# REZ2022-00026

## East West Communities

Staff Report for Board of Supervisors Public Hearing  
Prepared January 12, 2023

## 2.5 ARCADIA EAST MASTER PLAN VISION 3

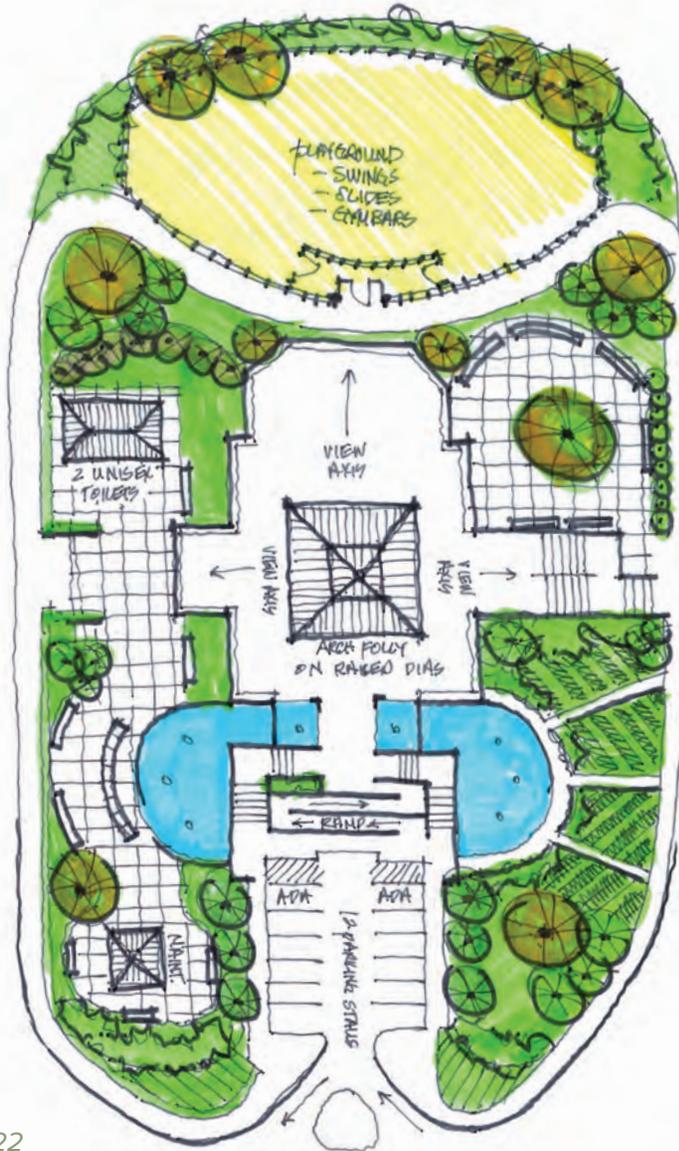
East Masterplan Vision 3 is not acceptable as shown as it exceeds the maximum number of dwelling units off a single point of access. Additionally, the private alley widths will be required to be a minimum clear width of 24 feet. The concrete aprons will be permitted to be incorporated into the total width.
